STATE OF UTAH
DEPARTMENT OF NATURAL RESOURCES
DIVISION OF OIL, GAS AND MINING

APPLICATION FOR PERMIT TO DRILL				1. WELL NAME and NUMBER Birmingham 23-15		
2. TYPE OF WORK DRILL NEW WELL <input checked="" type="checkbox"/> REENTER P&A WELL <input type="checkbox"/> DEEPEN WELL <input type="checkbox"/>				3. FIELD OR WILDCAT BLUEBELL

43047511140000 Birmingham 23-15

43047511140000 Birmingham 23-15Rev.

Casing Schematic

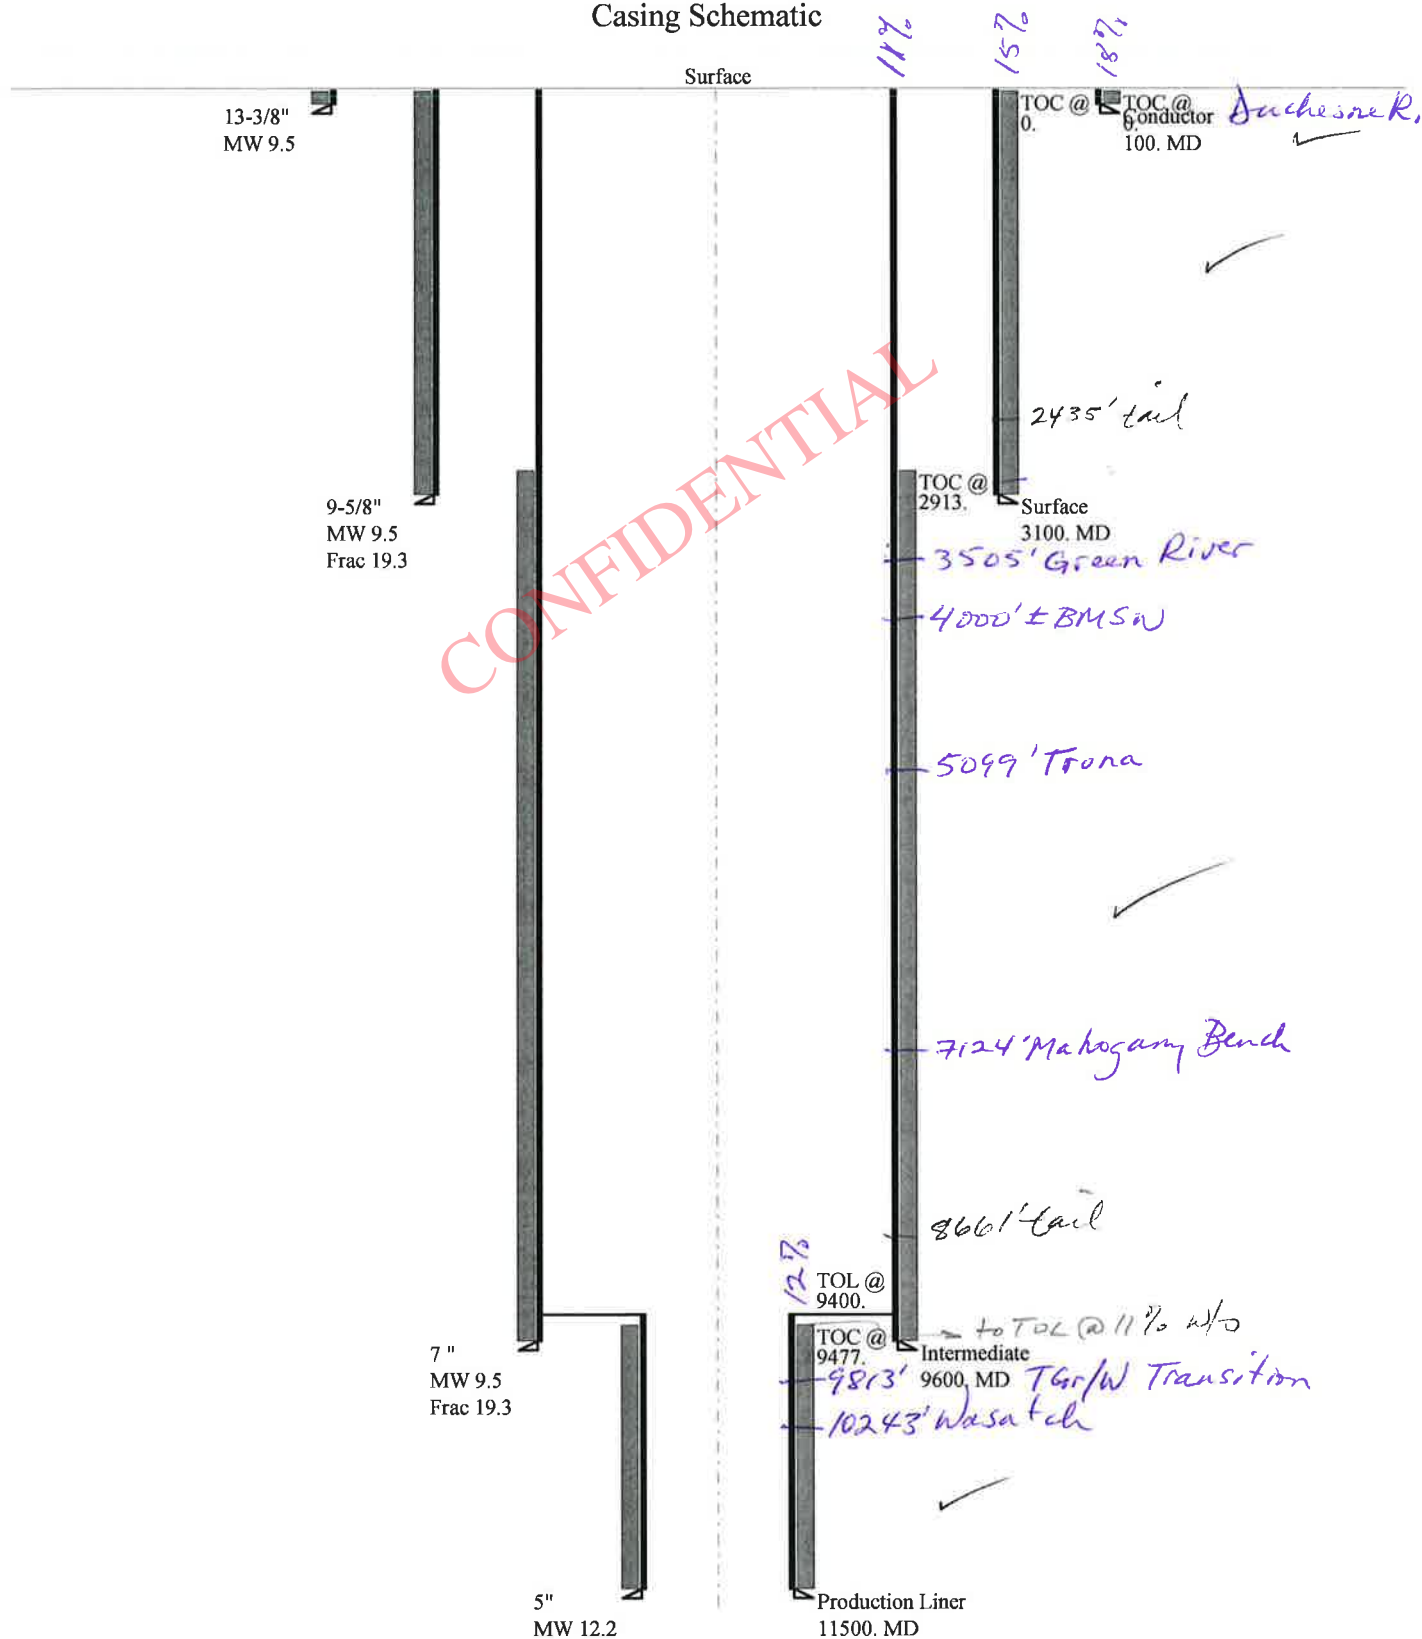
Collapse is based on a vertical depth of 100 ft, a mud weight of 9.5 ppg. The casing is considered to be evacuated for collapse purposes. Collapse strength is based on the Westcott, Dunlop & Kemler method of biaxial correction for tension.

Burst strength is not adjusted for tension.

Casing Schematic

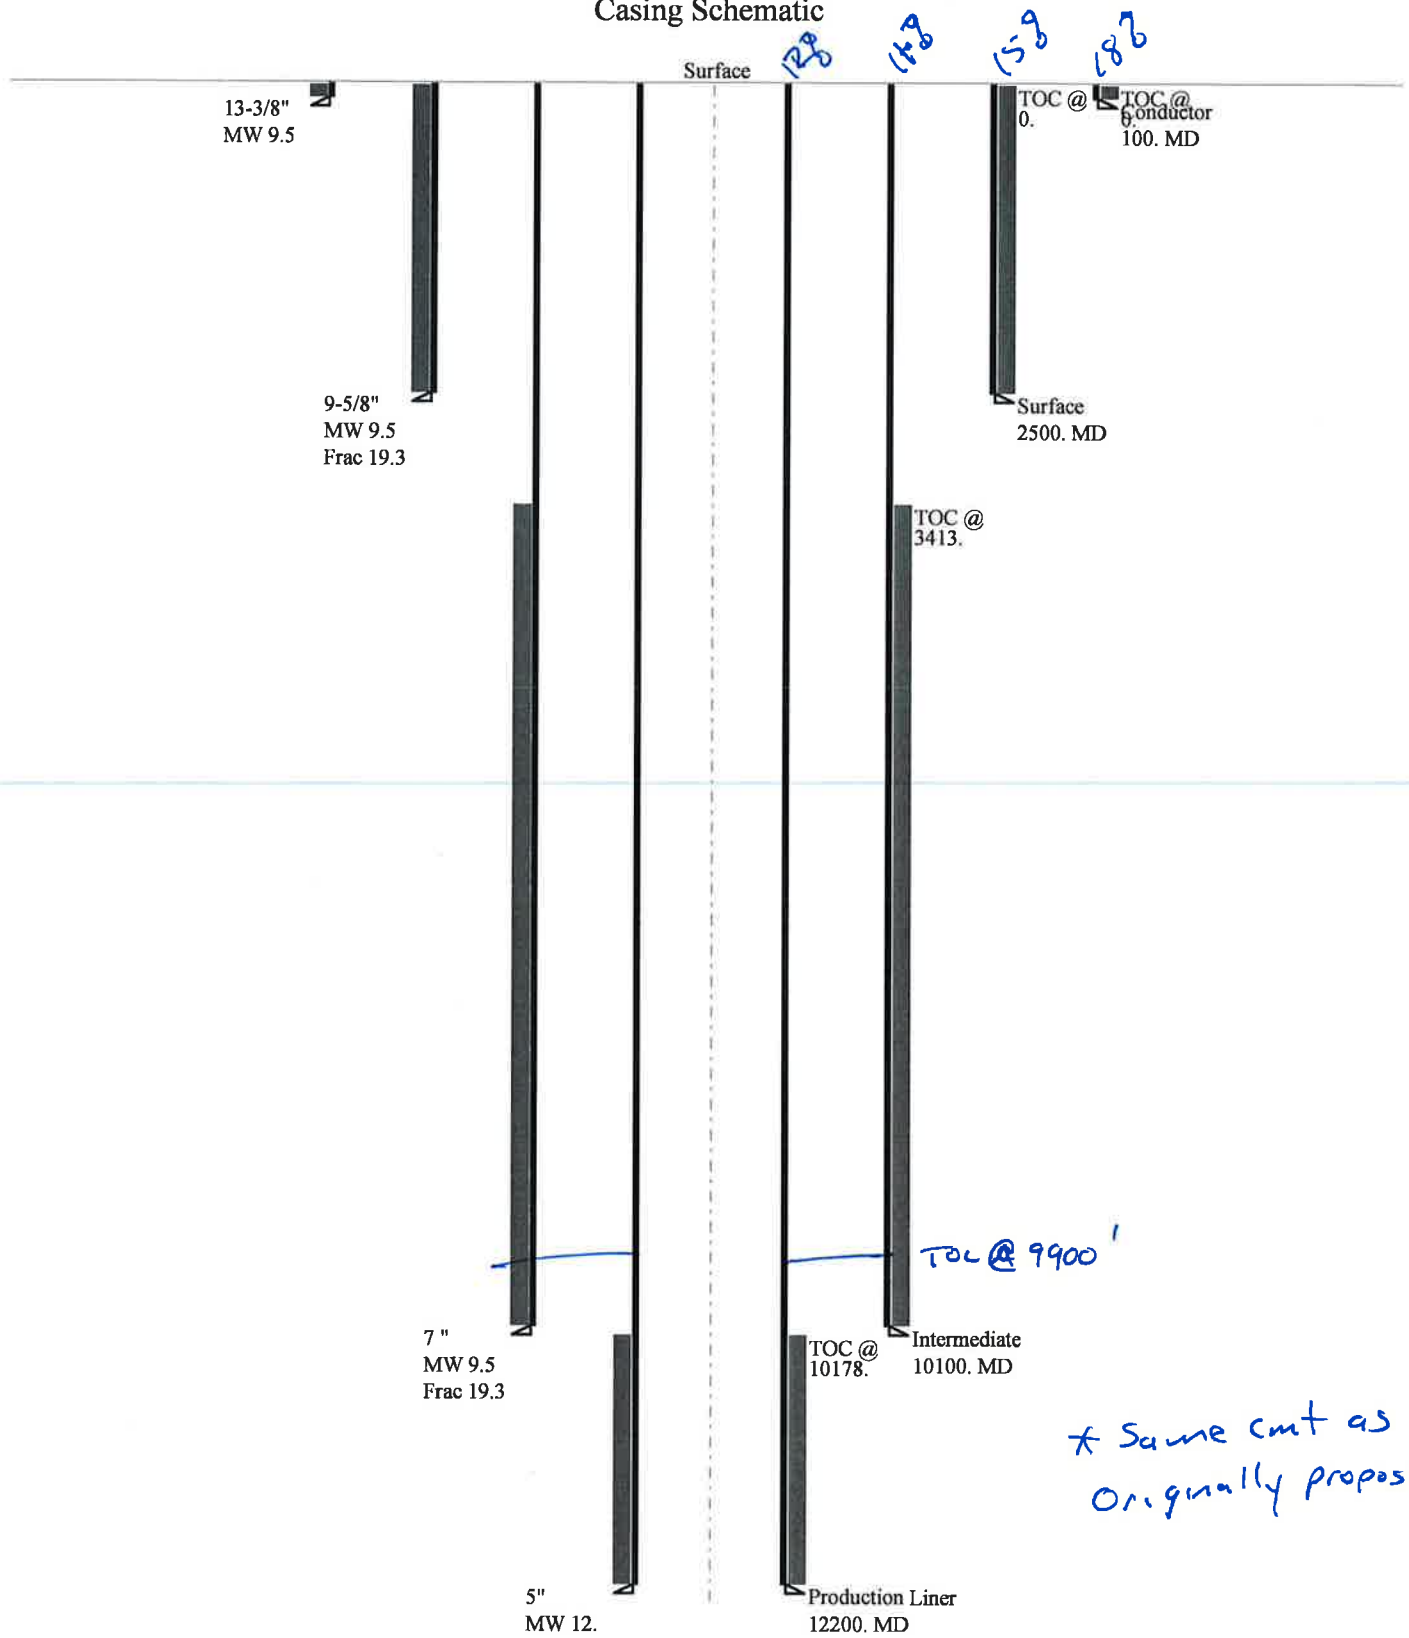
12. DESCRIBE PROPOSED OR COMPLETED OPERATIONS. Clearly show all pertinent details including dates, depths, volumes, etc.
 BBC hereby requests to revise the drilling plan for the subject well.
 Please see revised plan attached.
